ADDENDUM No. 1

Hoover Elementary School

2025 Stage Renovations

Arch. Project #240116

A1.0

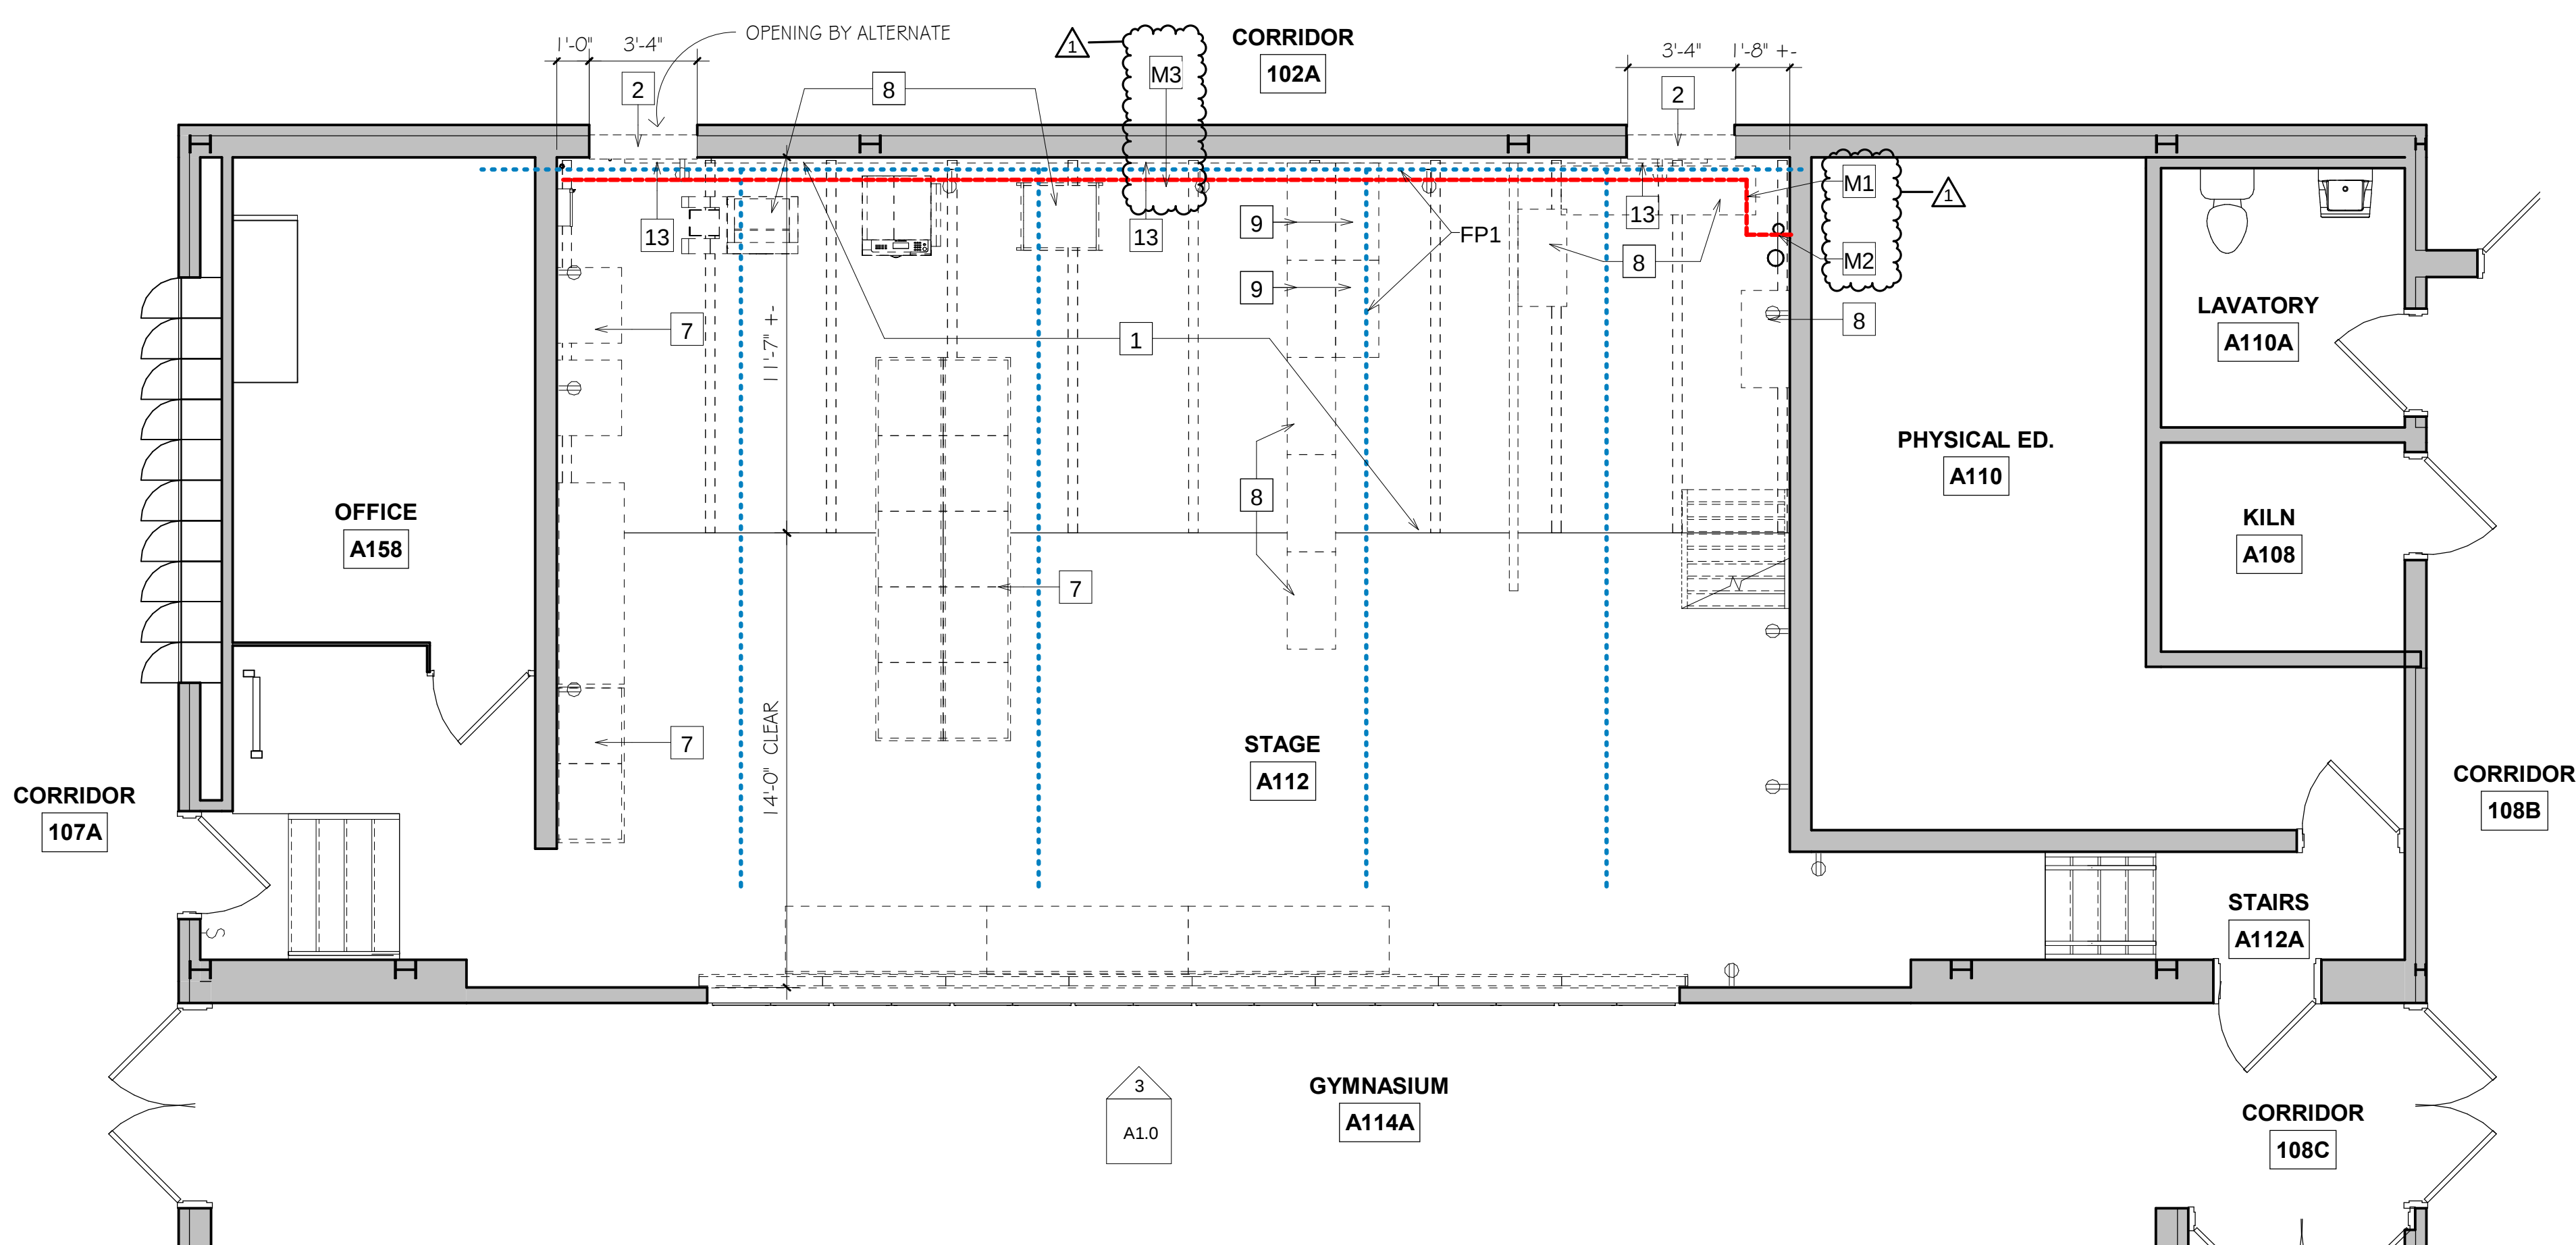
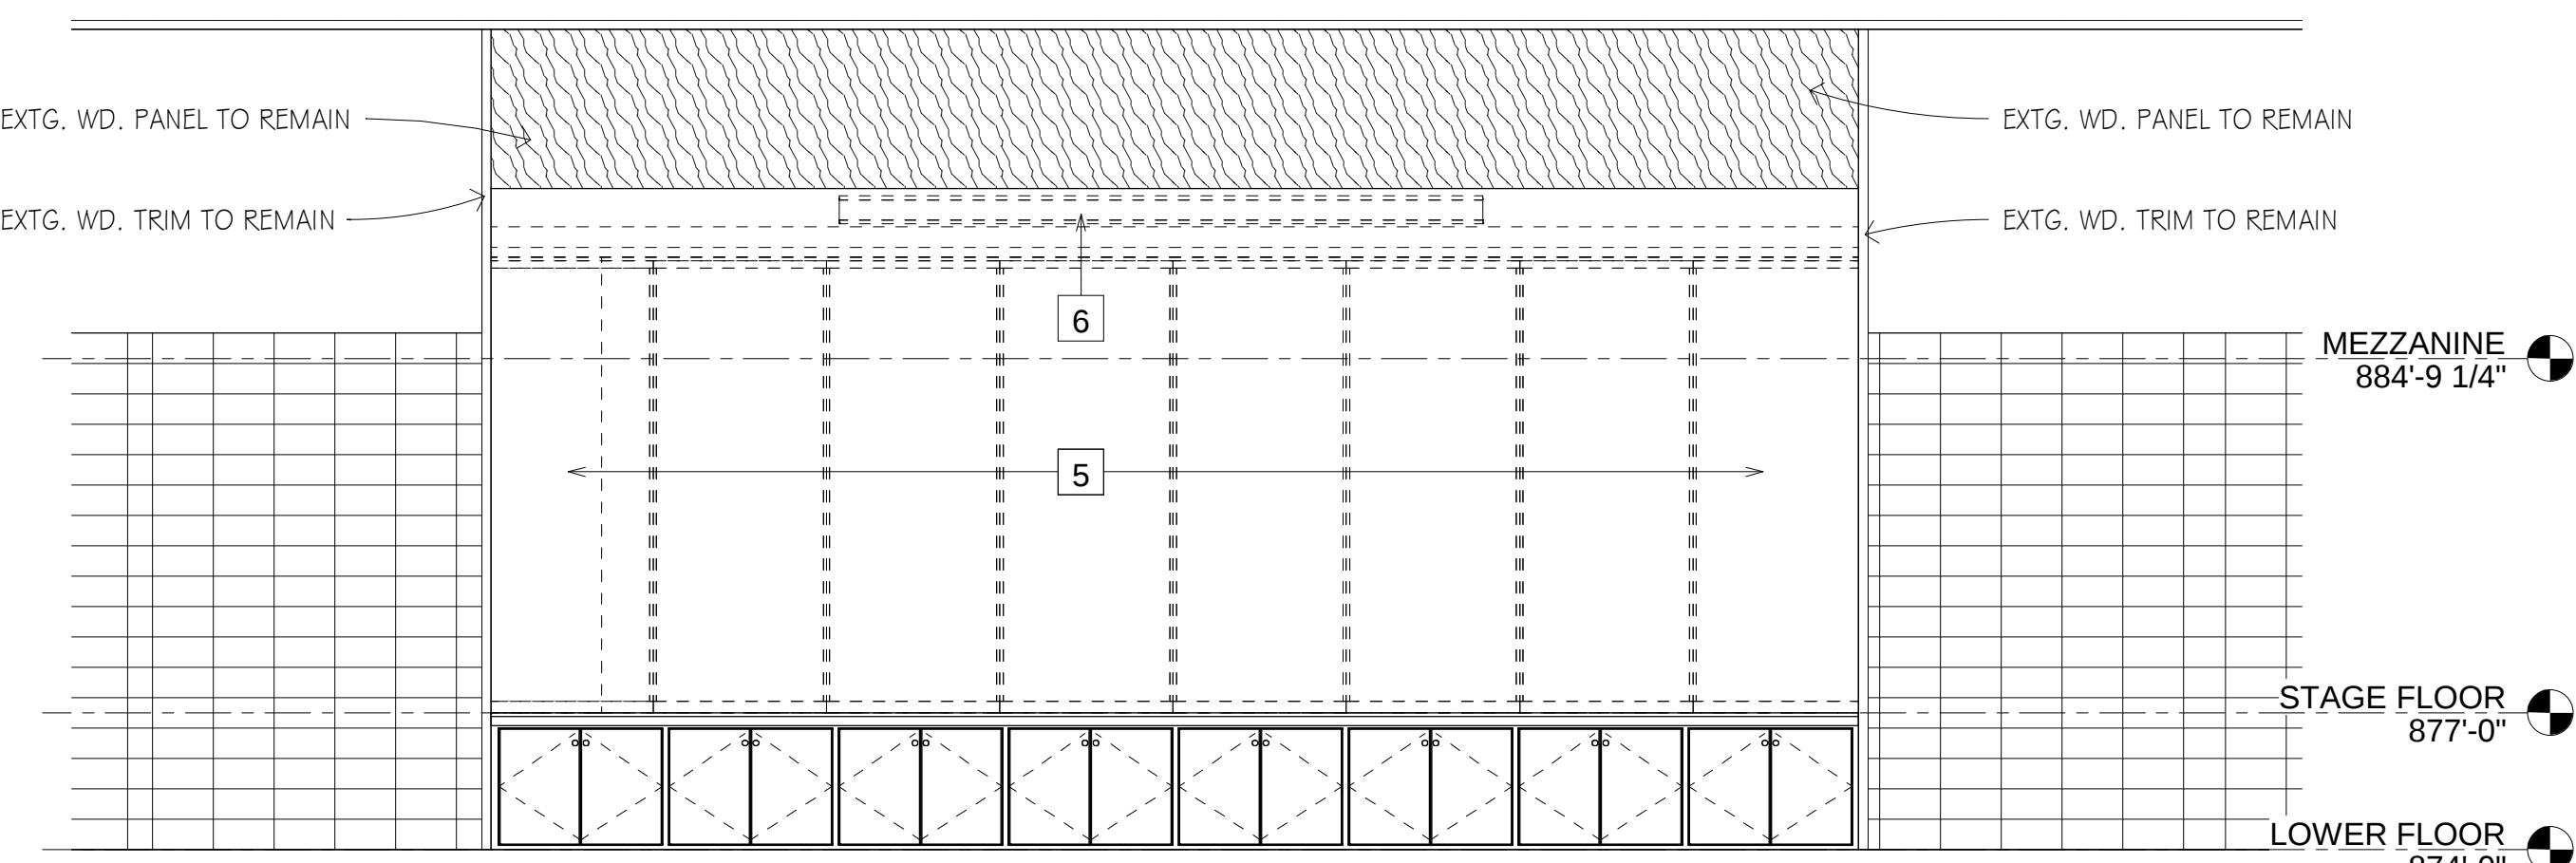
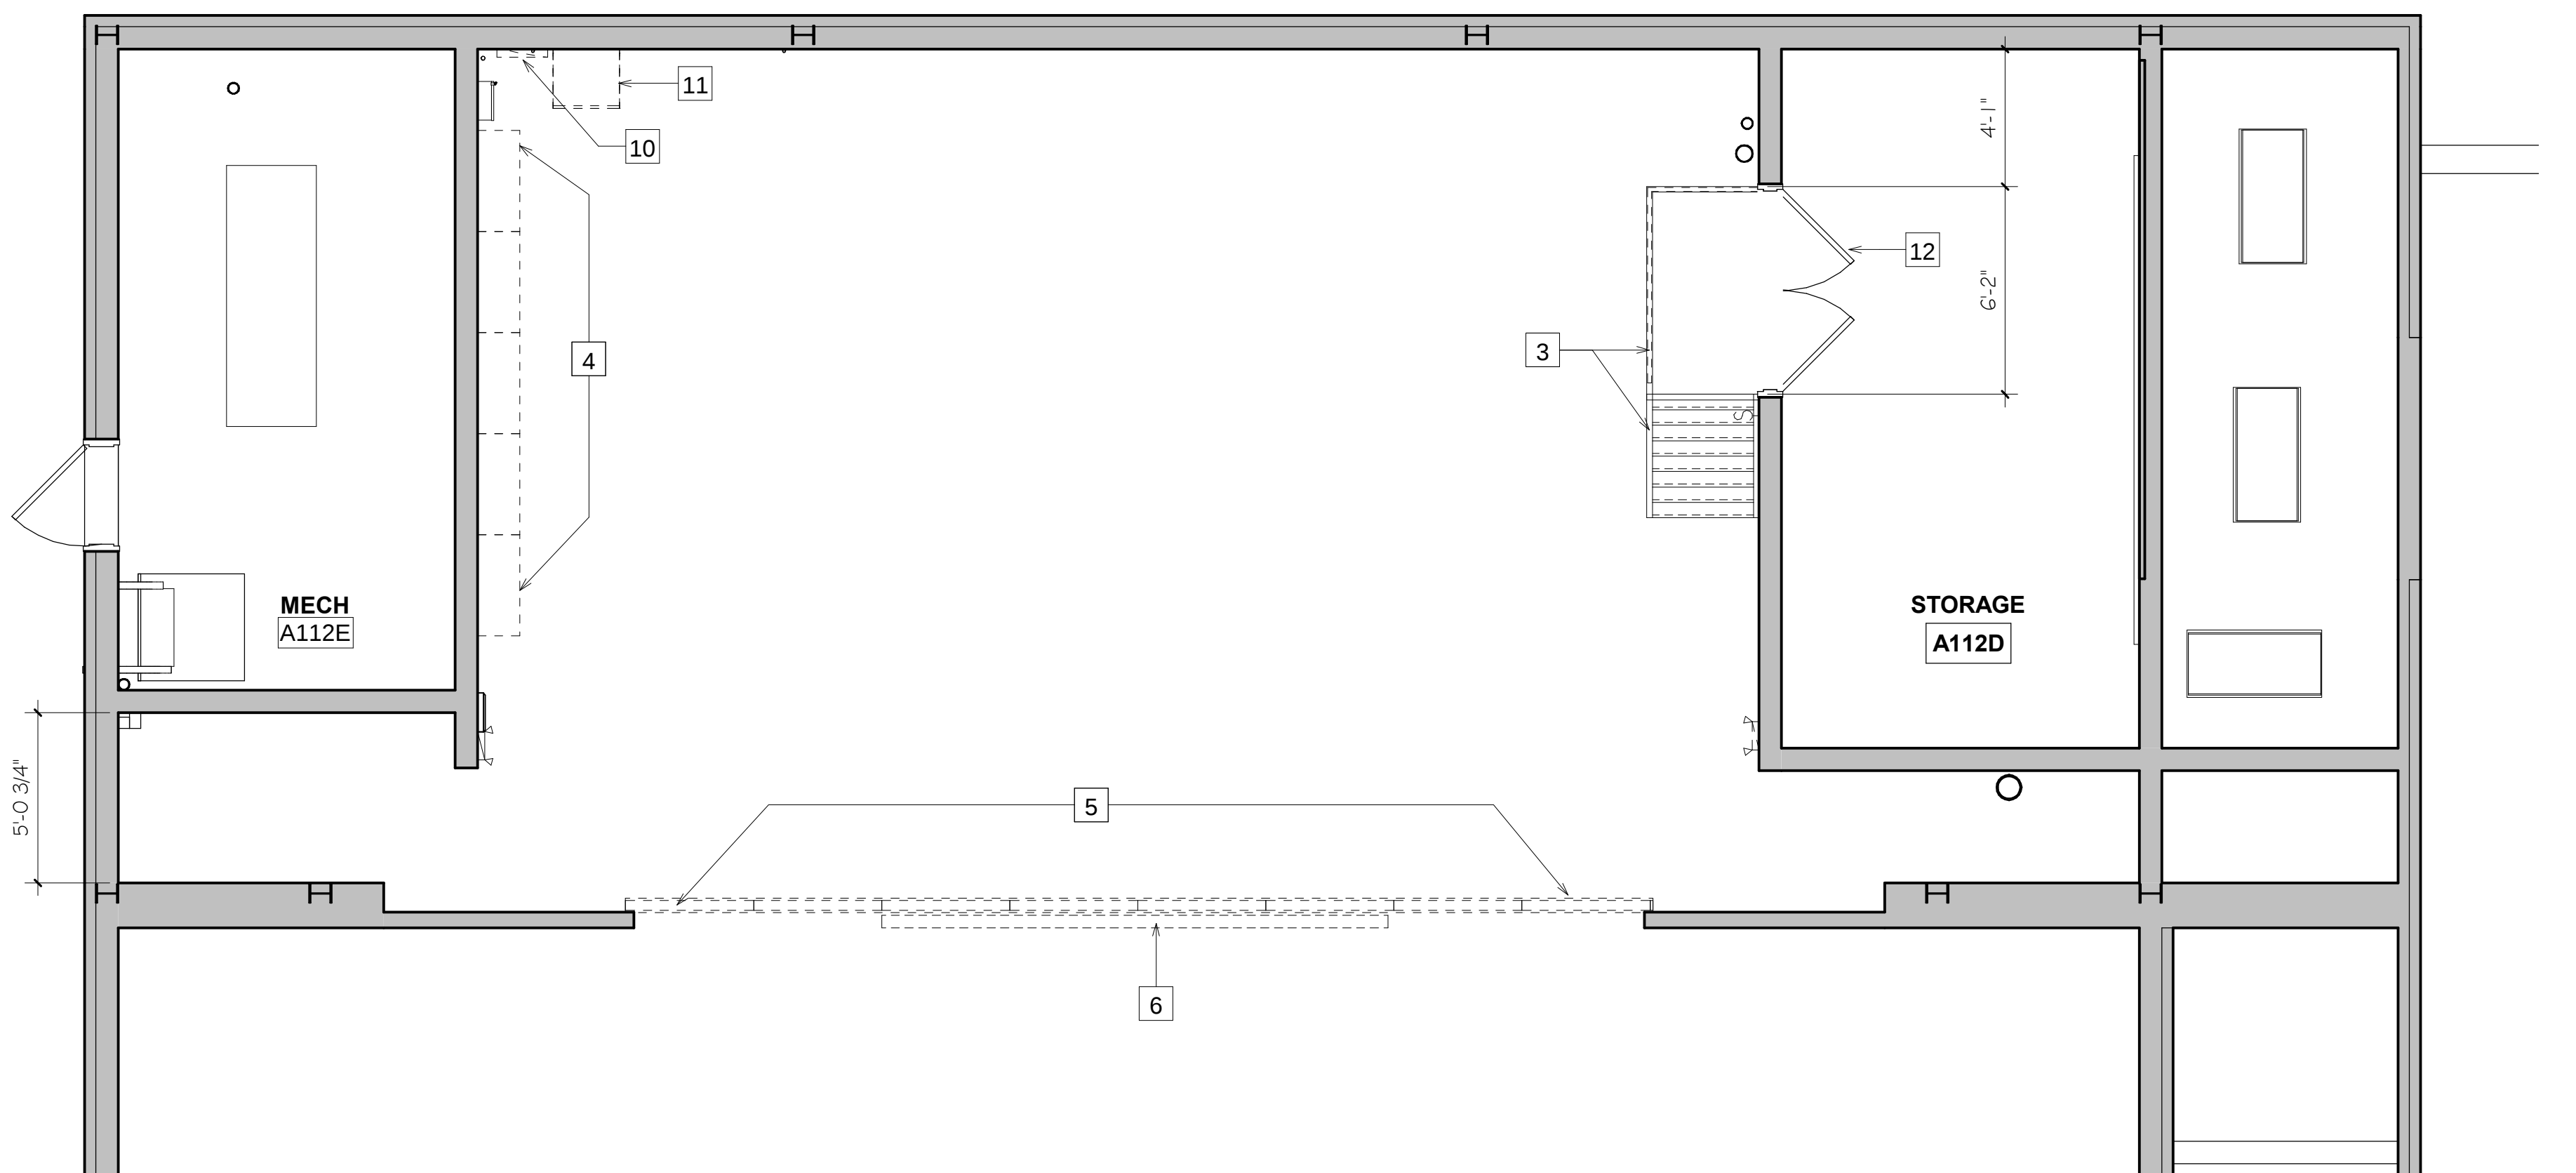
Sheet A1.0: Remove the list of alternates from this sheet. See specifications for alternates.

Sheet A1.0: Added note about low voltage cabling to Design Build Electrical paragraph.

Sheet A1.0: Added note M3 to demolition key notes and plan 1/A1.0.
